DECISION NO. RRJ0000-OR-470-7229

for replacement of the bolts providing the reduced tightness in the connection joint of the attachment mounts with the horizontal stabilizer hinge bracket on the RRJ-95 aircraft

**Procedure for
replacement of T7.92.3100.077.000.73 hollow bolts to T7.92.3100.177.000.73 bolts**

Demounting of the hollow bolts (T7.92.3100.077.000.73) along the upper hinge fitting
of the stabilizer
Figure 1 (sheet 1 of 3)

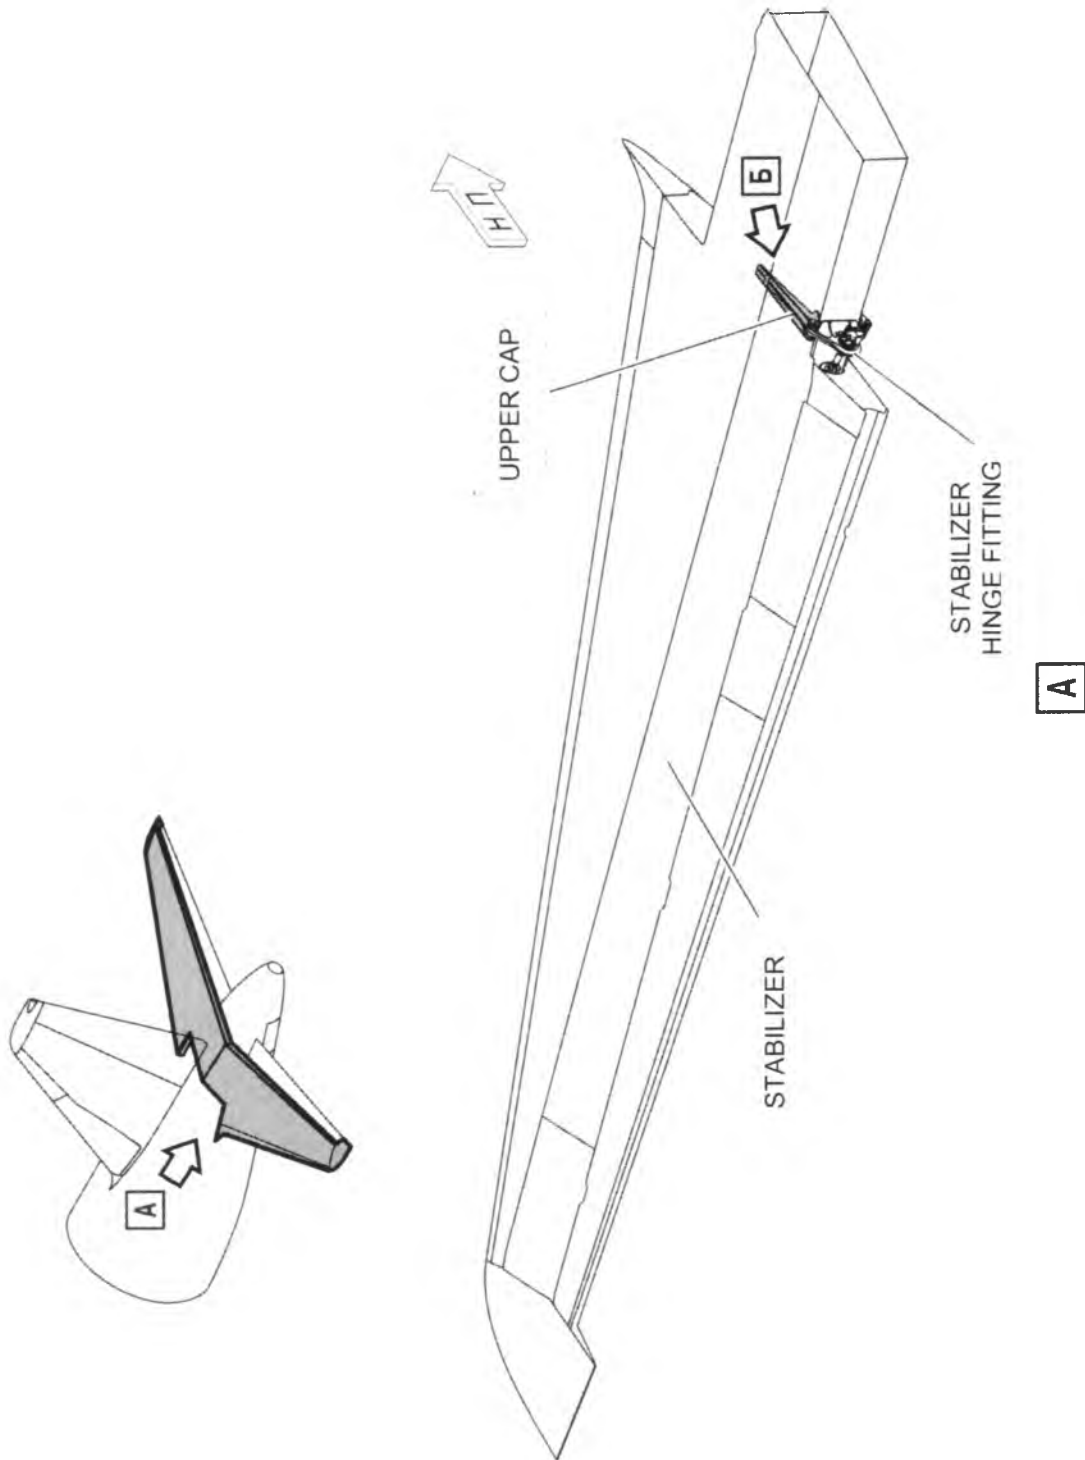
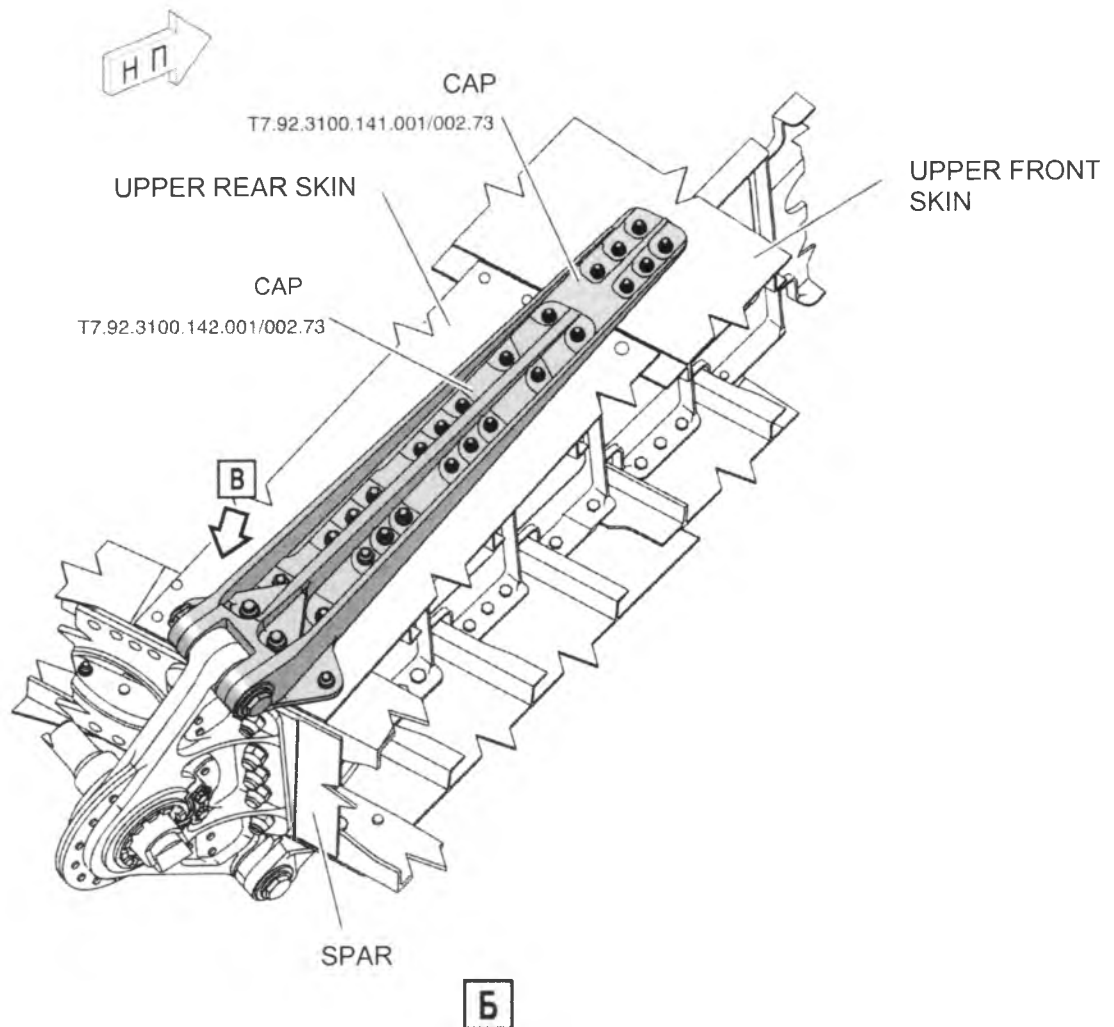
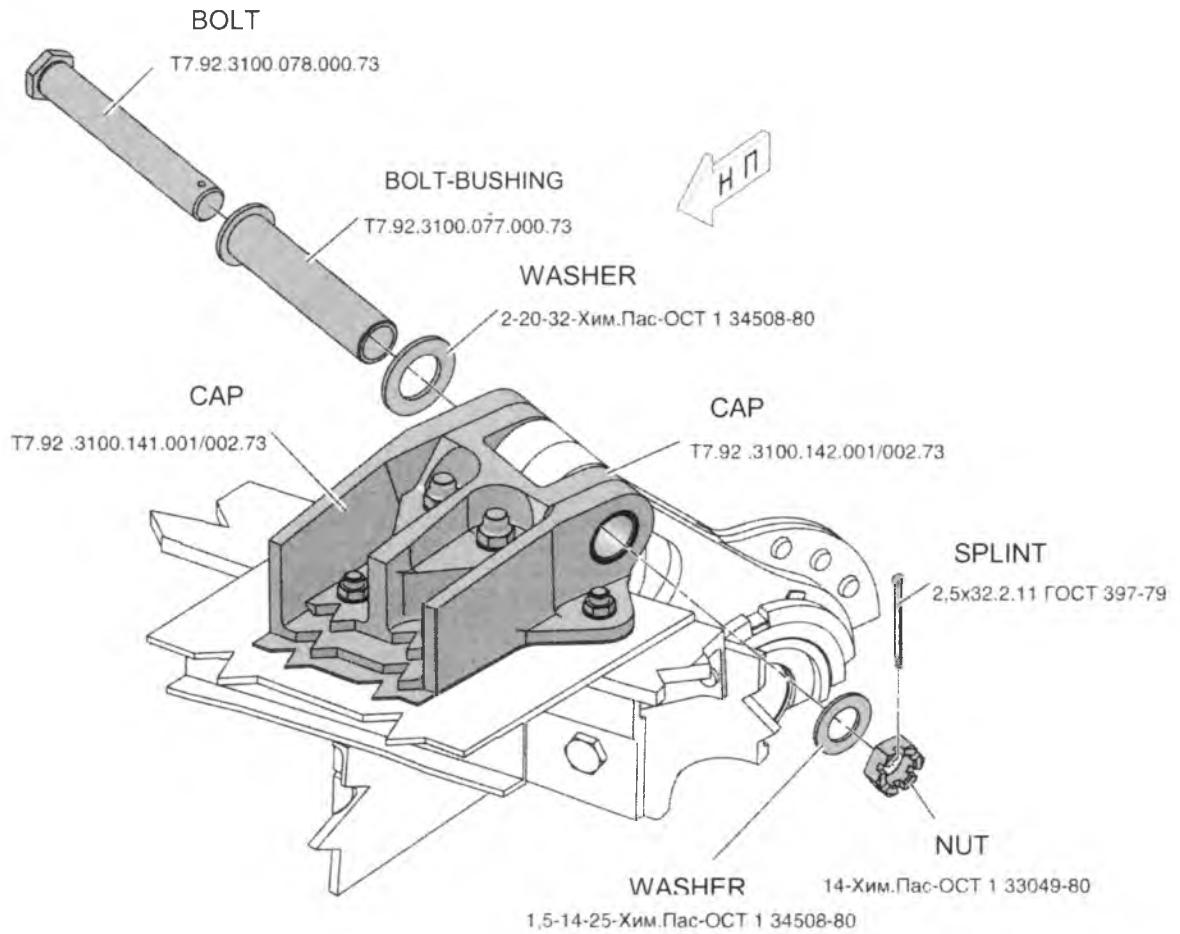
- (1) Demounting of the hollow bolt (T7.92.3100.077.000.73) along the upper hinge fitting of the stabilizer (see Fig. 1).
 - (a) Clean the surfaces of the upper cap from dirt with cleaning rags dampened with НЕФРАС-C2-80/120 solvent if necessary.
 - (б) Remove the 22,5x32.2.11 ГОСТ 397-79 splint and discard it.
 - (в) Remove the 14-Хим.Пас-ОСТ 1 33049-80 nut of the upper cap attachment to the fitting of the stabilizer. Save the nut for the further installation
 - (г) Remove 1,5-14-25-Хим.Пас-ОСТ 1 34508-80 washer and save it for the further installation.
 - (д) Remove the bolt (T7.92.3100.078.000.73) and save it for the further installation.
 - (е) Carefully remove the bolt-bushing (T7.92.3100.077.000.73) from the lugs of the upper cap. Discard the bolt-bushing.
 - (ж) Remove 2-20-32-Хим.Пас-ОСТ 1 34508-80 washer and save it for the further installation.

Installation of the hollow bolt (T7.92.3100.177.000.73) along the upper hinge fitting of the stabilizer
Figure 2 (sheet 1 of 3)

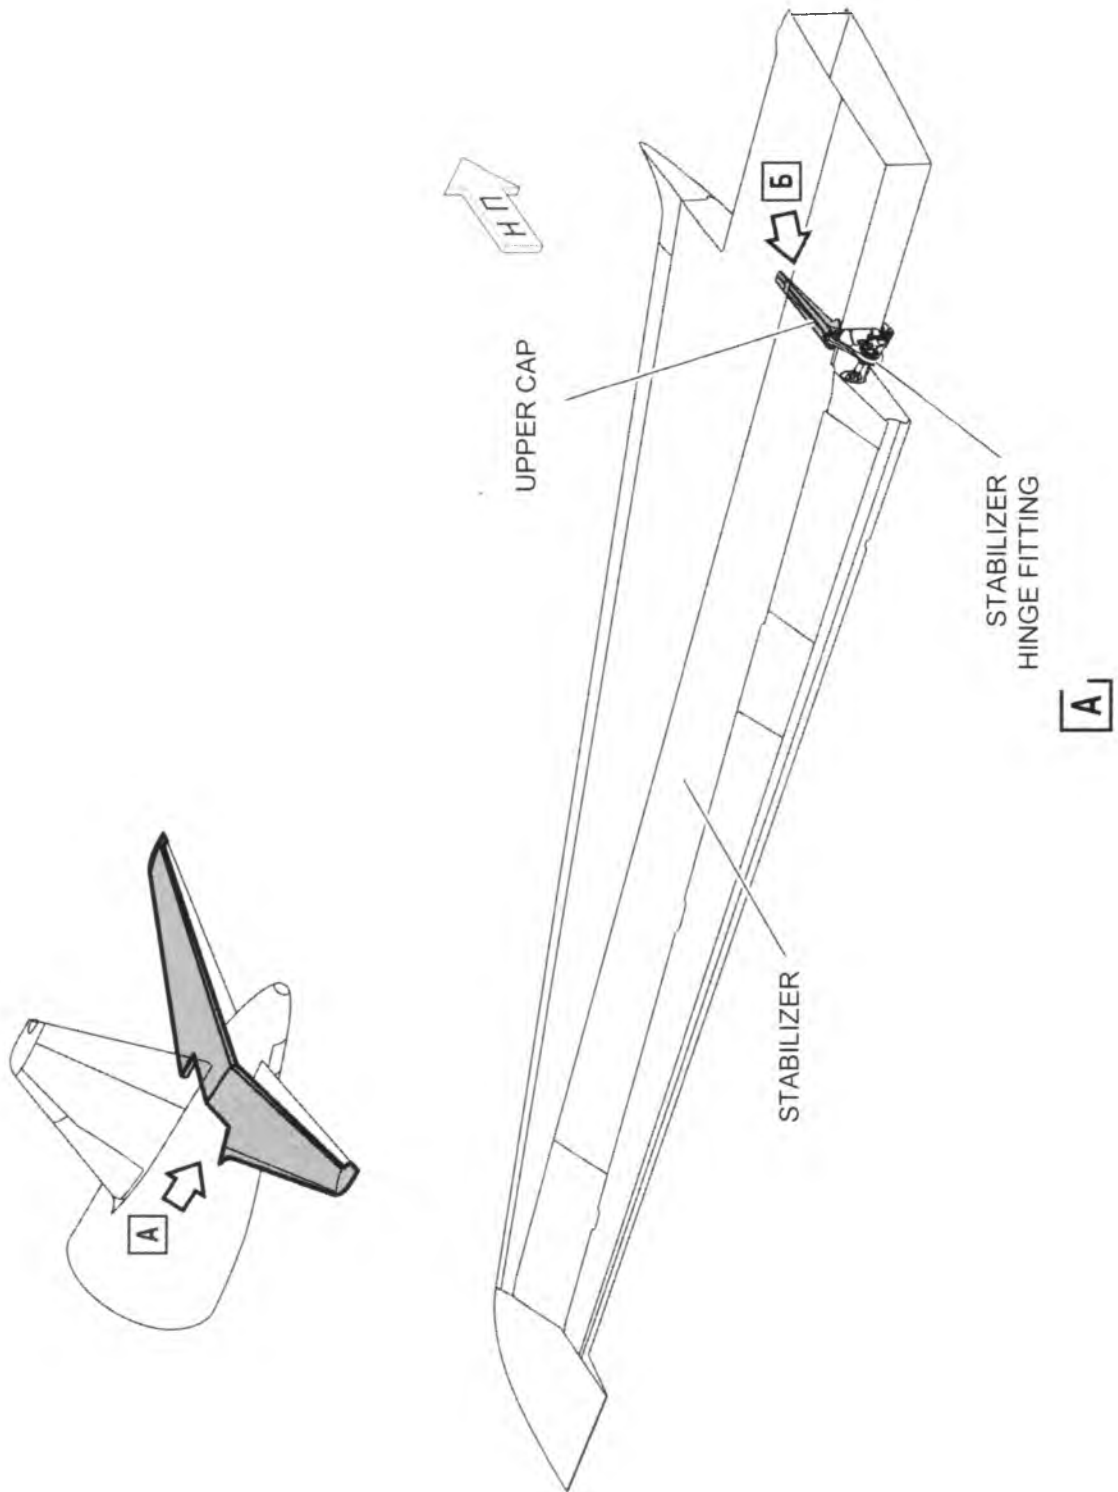
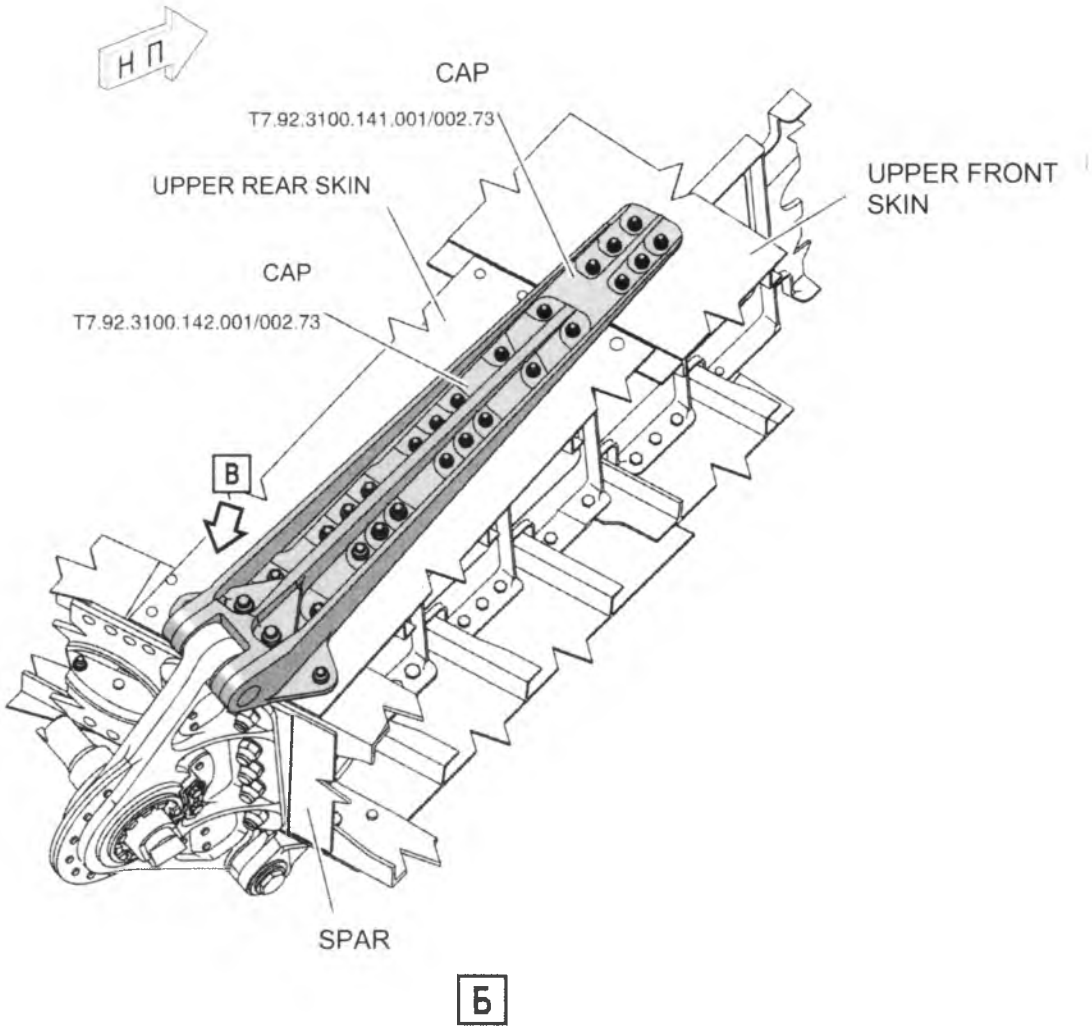
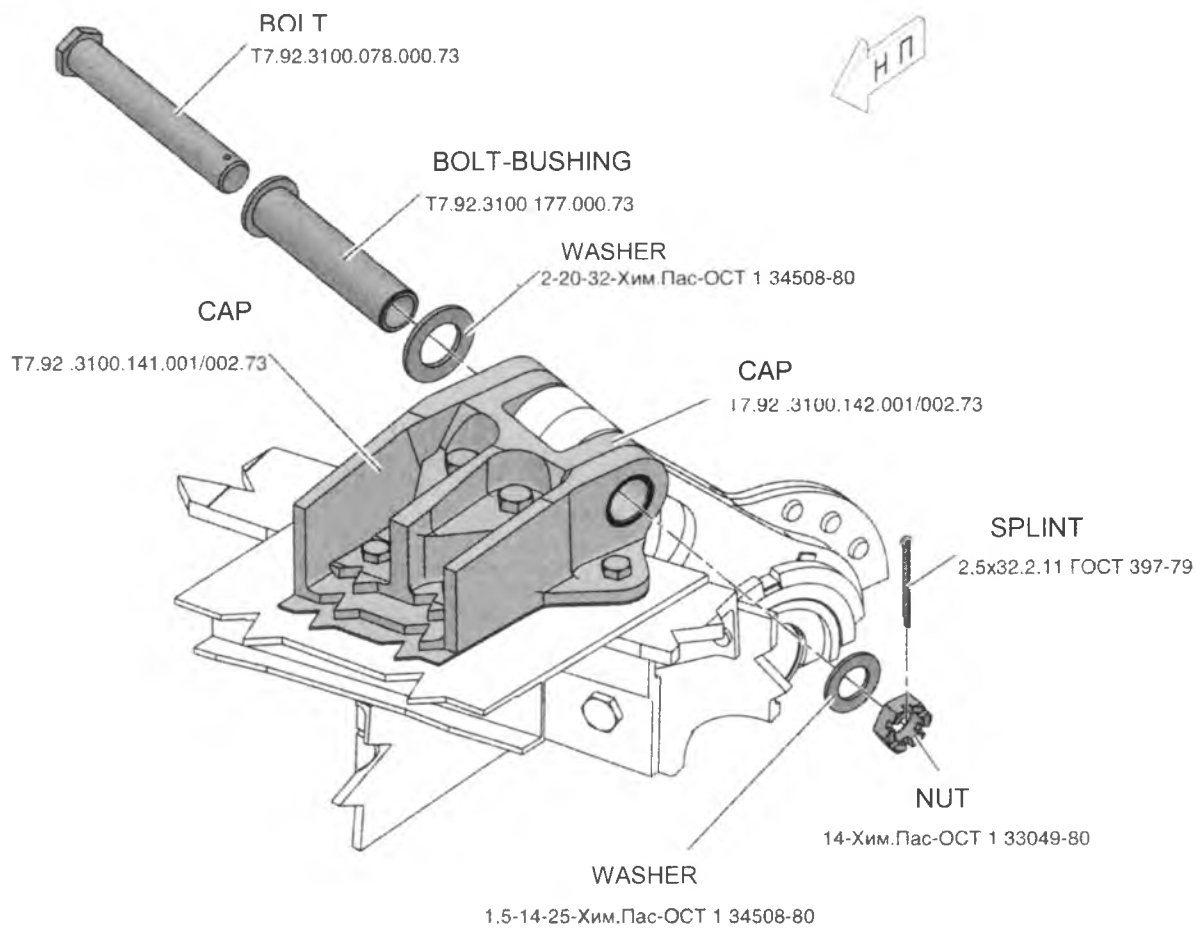
(2) Installation of the hollow bolt (T7.92.3100.177.000.73) along the upper hinge fitting of the stabilizer (see Fig. 2).

(a) Install the previously removed 2-20-32-Хим.Пас-ОСТ 1 34508-80 washer and new bolt-bushing (T7.92.3100.177.000.73) to the lug of the upper cap.

(б) Install the previously removed bolt (T7.92.3100.078.000.73).

(в) Install the previously removed 1,5-14-25-Хим.Пас-ОСТ 1 34508-80 washer.

(г) Install the previously removed 14-Хим.Пас-ОСТ 1 33049-80 nut.

(д) Install new 2.5x32.2.11 ГОСТ 397-79 splint.
